Access Compliance Report

Public Rights-of-Way

| Intersection ID: 42483 | Main Street: BLAKENEY GREENS BV | Cross Street: BULLOCK GREENWAY BV | Location: E |
| ADA ID: D6B257DF9A9F | Ramp Type: PerpDiag | Initial Pass/Fail: Fail | Overall Compliance: No |

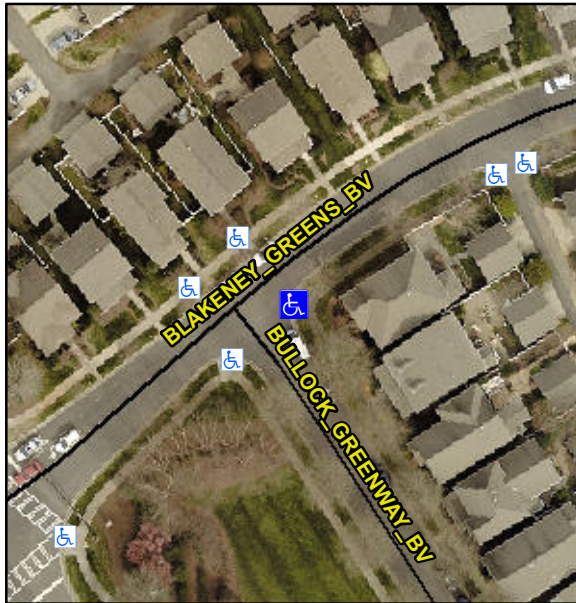
R304.5.1

| Compliance | Description | Data | Compliance | Description | Data |
|------------|-----------------------|-------|------------|-----------------------------|-------|
| No | Ramp Width (in) | 32.0 | Yes | Ramp XSlope (%) | 1.4 |

Remove & Replace Curb Ramp With Two New Directional Ramps or Equivalent.
